2700 ELLIOTT AVENUE  
**JOSEPH ARNOLD LOFTS**  
DESIGN REVIEW RECOMMENDATION MEETING #2

DPD NO.3009932

JUNE 28, 2011

### INITIAL RECOMMENDATION OF THE DOWNTOWN DESIGN REVIEW BOARD

west elevation - detail at podium base

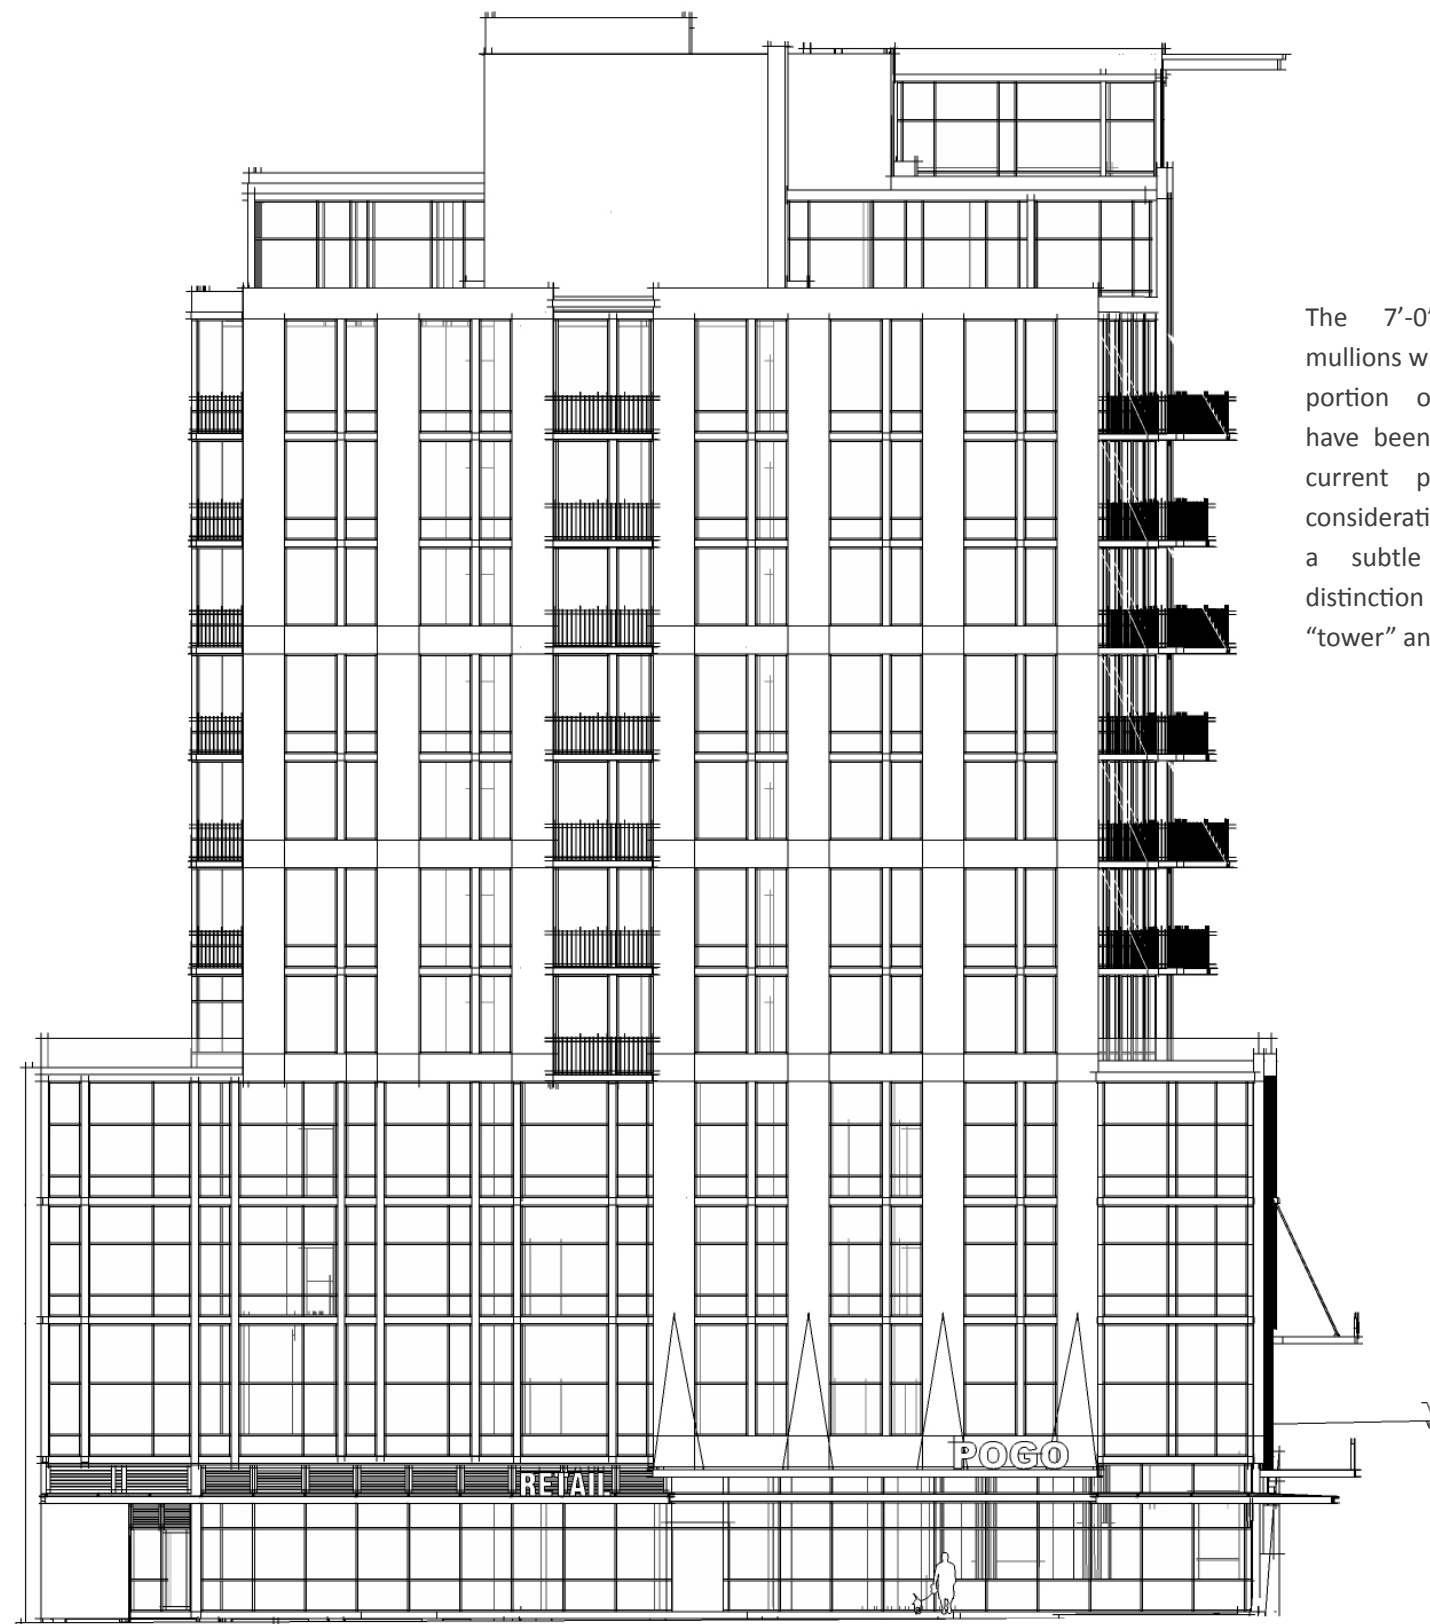
The Board observed that the Cedar St. façade was successful and requested that the Elliott Ave. façade be further designed to reflect and relate better to the one on Cedar St. The Cedar St. façade has a “frame” expressing a base which should be more closely approximated on Elliott Ave. It stated that Cedar St. façade “wants to” wrap around the corner. And while the sharp angularity of the bay window element is OK, it needs to be deeper to be more obvious.

Although we acknowledge the DRB’s request to echo the Cedar Street frame base along Elliott, our approach considers the frames’ impact on the light and window area available to the units along Elliott and the building’s use of the frames as “two-dimensional” objects -- representing discontinuous planes rather than solids.

The west elevation has been simplified and revised to improve the diagrammatic clarity of the base -- as a primarily glass box who’s principal mullions “weave” into and behind the concrete frames above and along Cedar.

The 7'-0" h. window mullions within the "tower" portion of the building have been deleted in this current proposal. This consideration reinforces a subtle but effective distinction between the "tower" and base elements.

## Additional Definition of Rooftop Element

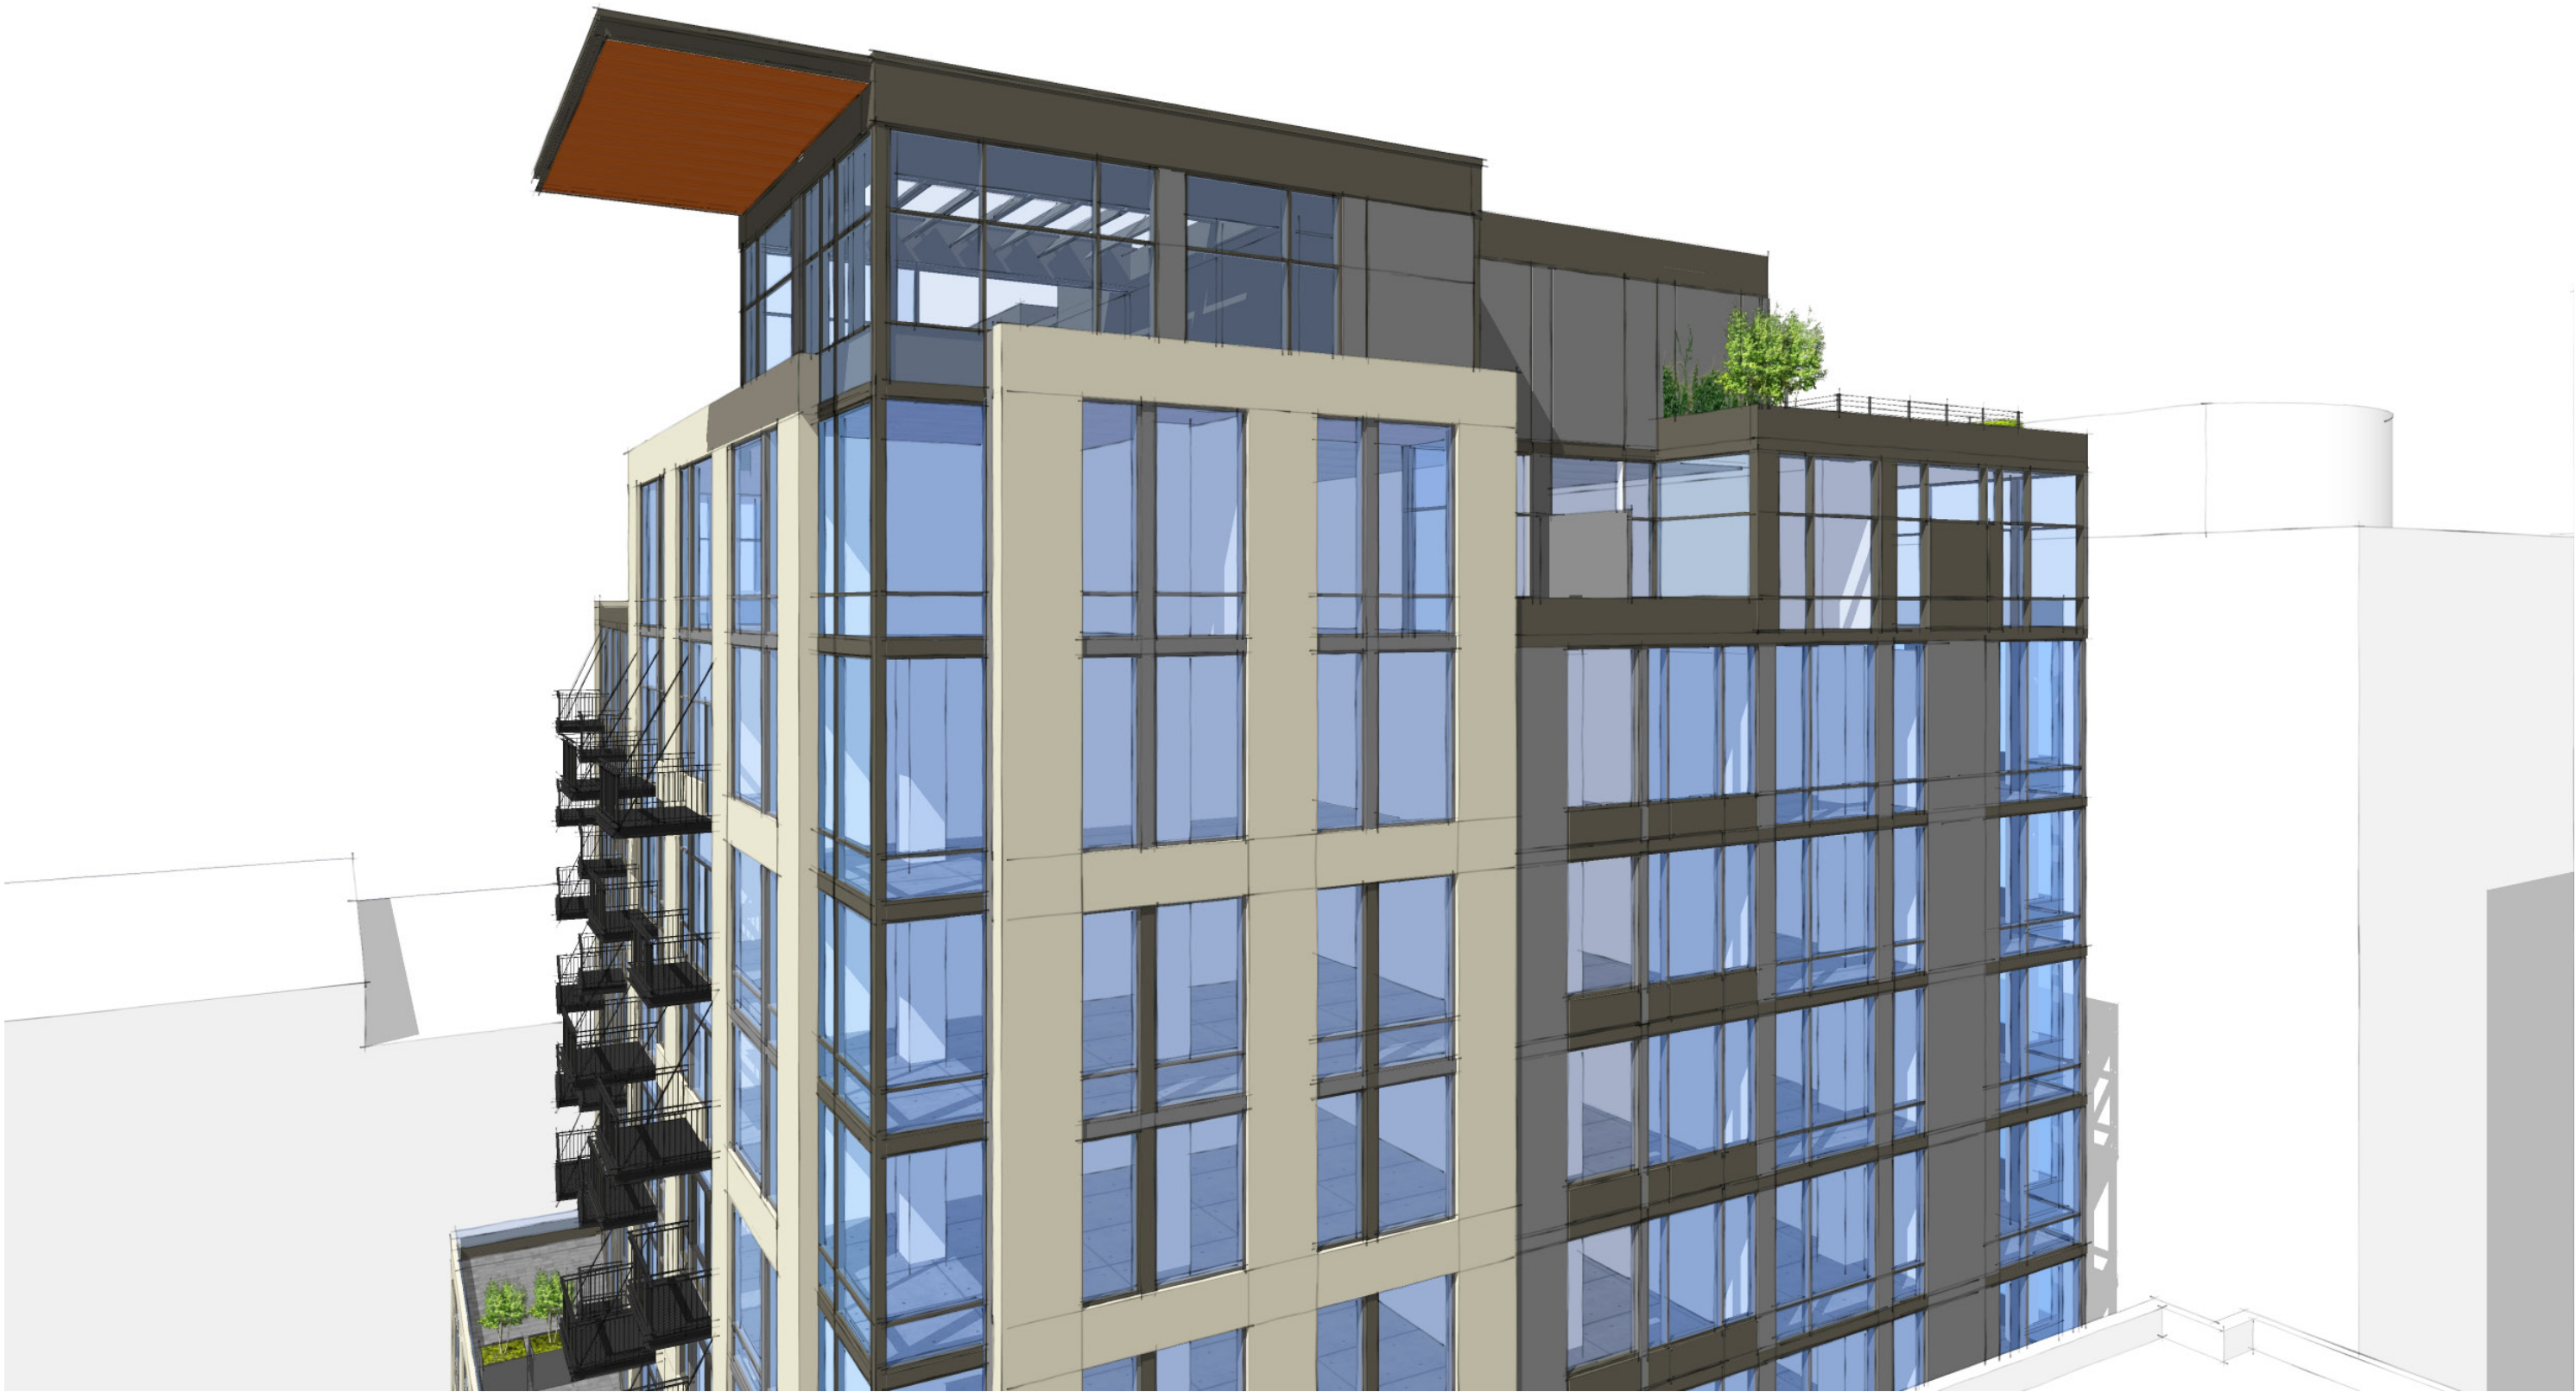
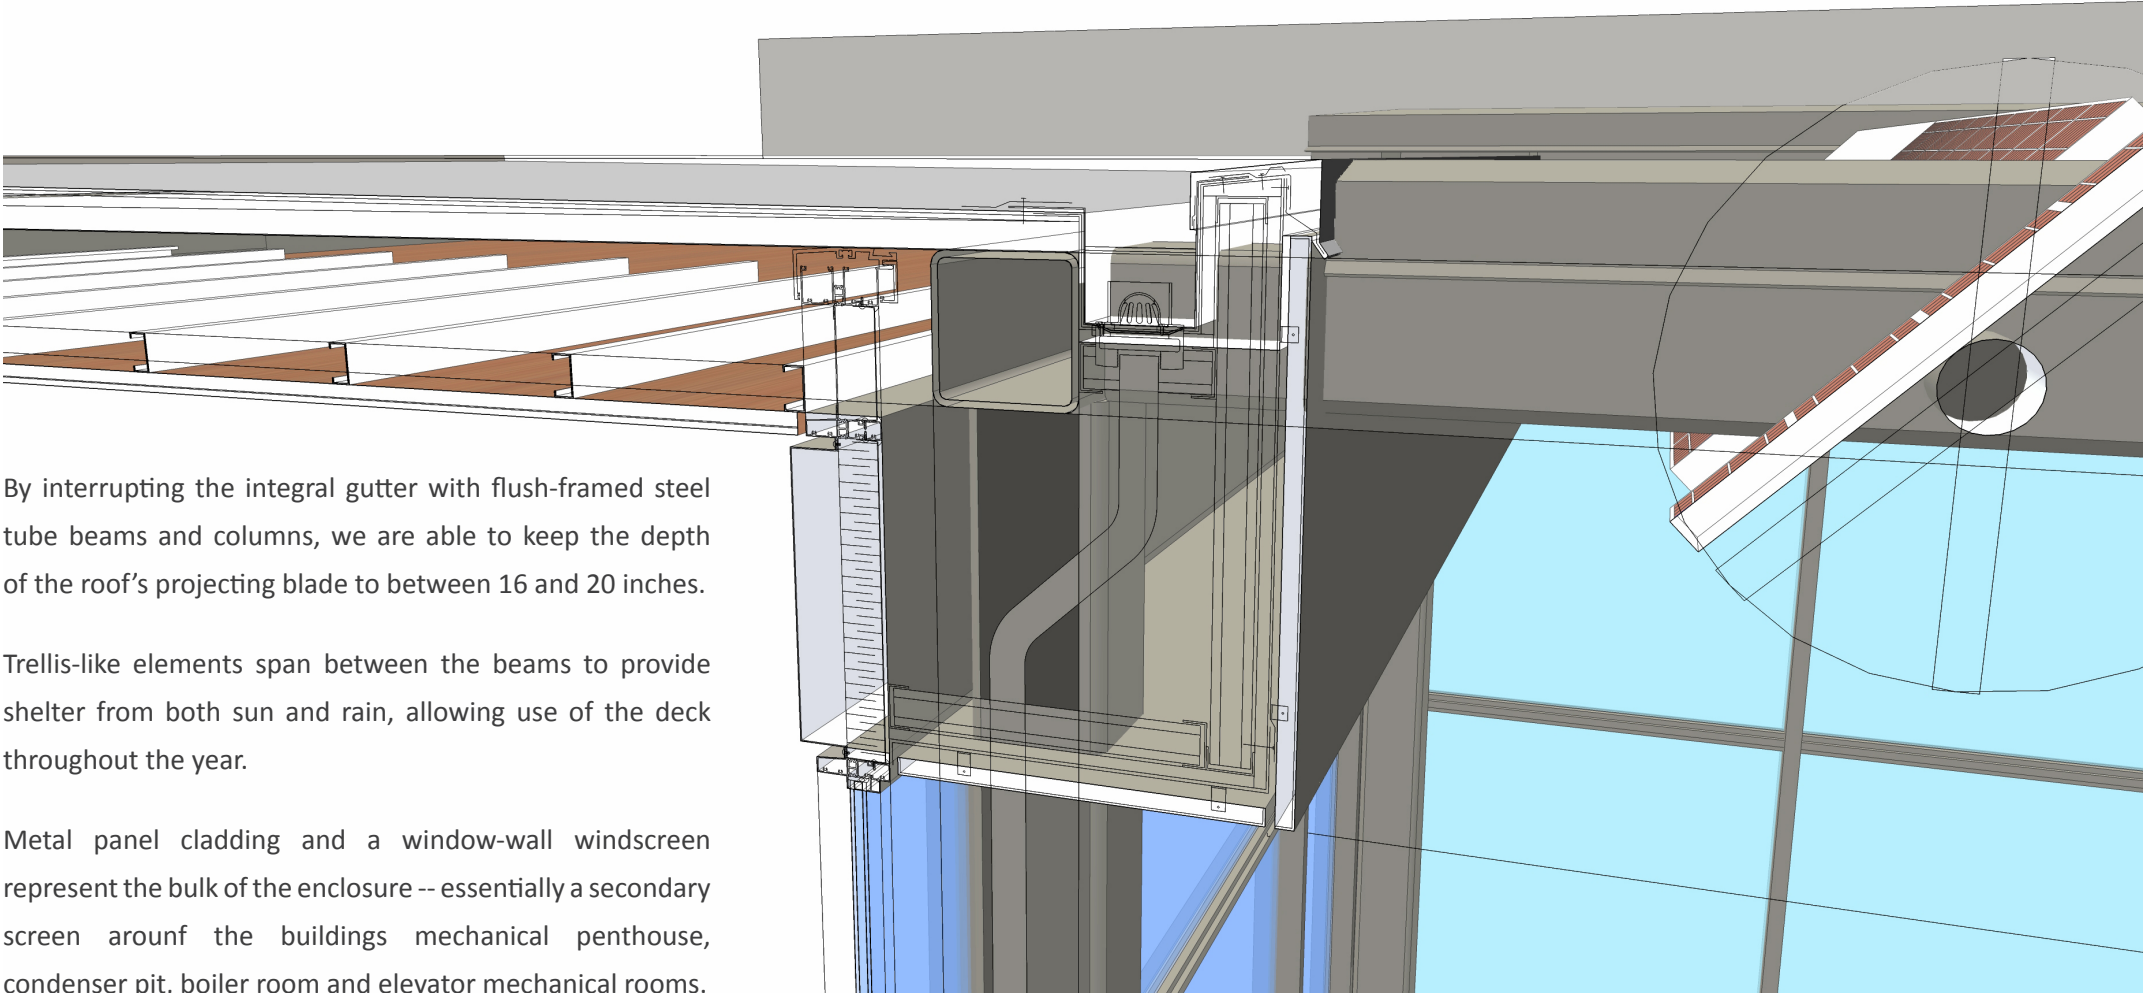
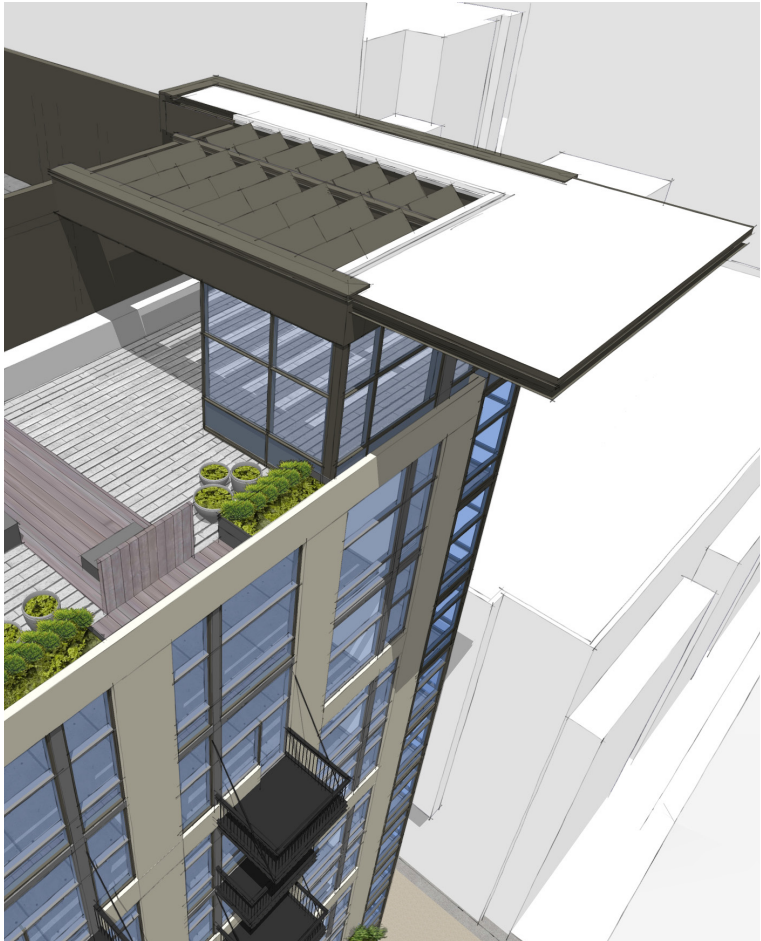
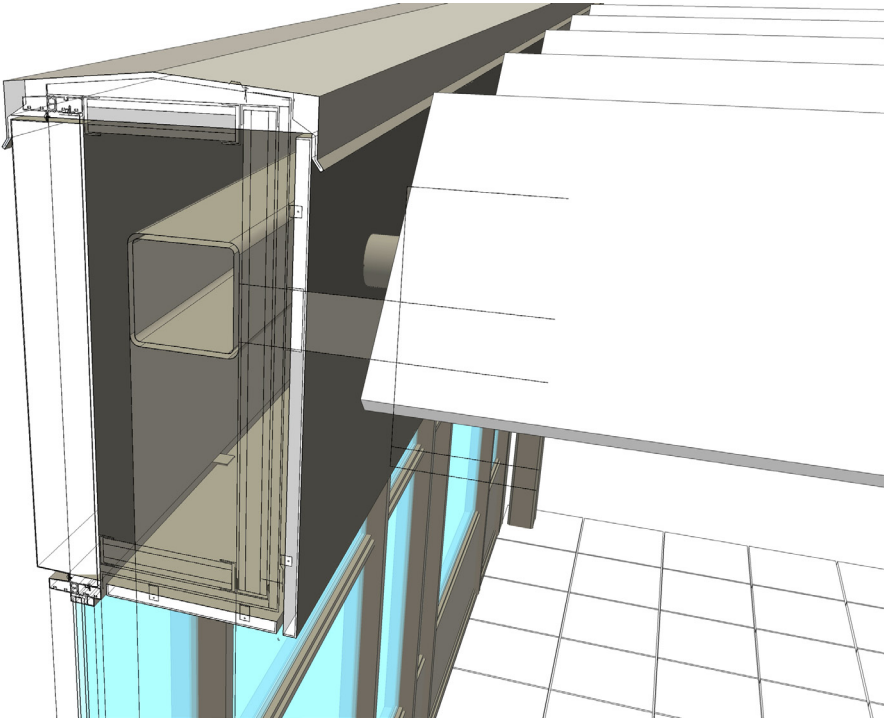
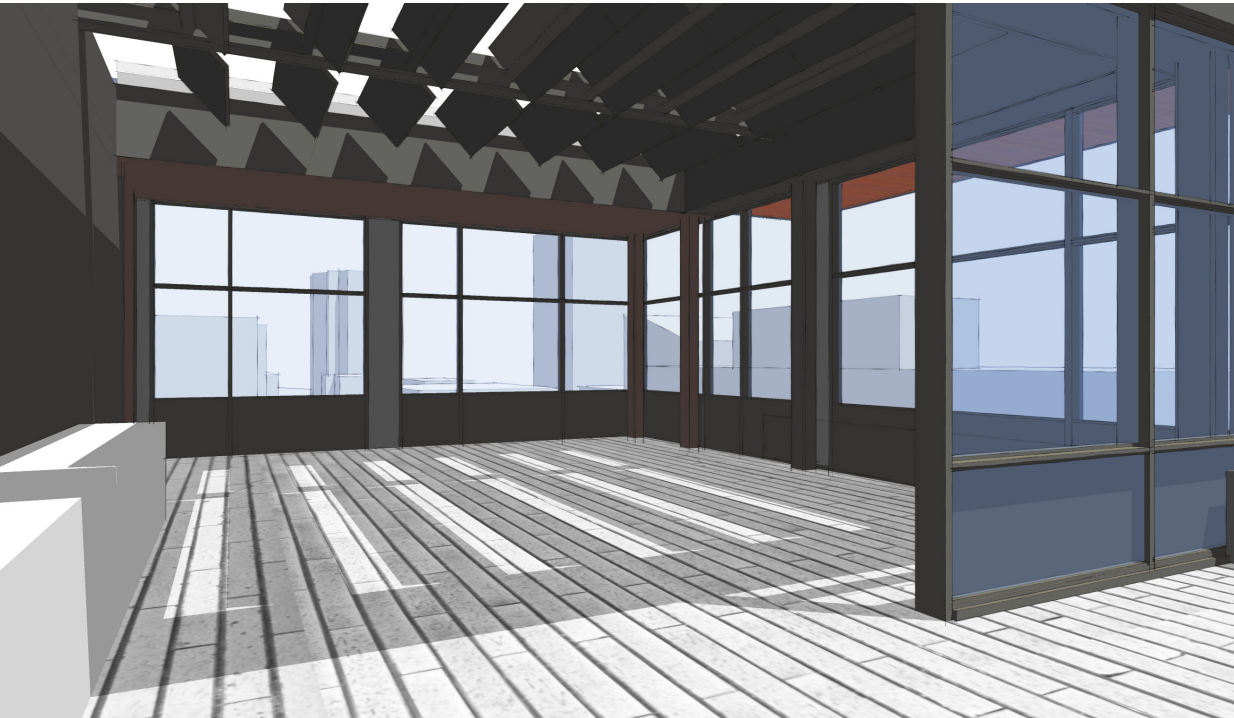
- The colors shown have a dark value. It is a pretty grey city at times. Should the values used be brighter?
- The rooftop and other “eyebrow” elements used as a building theme need to be well executed. How are they actually to be built? They should be designed to a more detailed state to thoroughly depict how they would be executed.

The Board stated they want to see detailing of the railings and of the “eyebrow” overhang elements at the next meeting. Concern was expressed that the features might fail to convey substance and quality and be a positive addition to the building if they were not properly designed and executed.

The Design Review Board requested additional definition and detailing of the rooftop identity feature that shelters the residents' amenity terrace. The goal was to ensure that the element ultimately built would be most similar to the one represented in the DRB materials.

By interrupting the integral gutter with flush-framed steel tube beams and columns, we are able to keep the depth of the roof's projecting blade to between 16 and 20 inches.

Trellis-like elements span between the beams to provide shelter from both sun and rain, allowing use of the deck throughout the year.

Metal panel cladding and a window-wall windscreen represent the bulk of the enclosure -- essentially a secondary screen around the buildings mechanical penthouse, condenser pit, boiler room and elevator mechanical rooms.
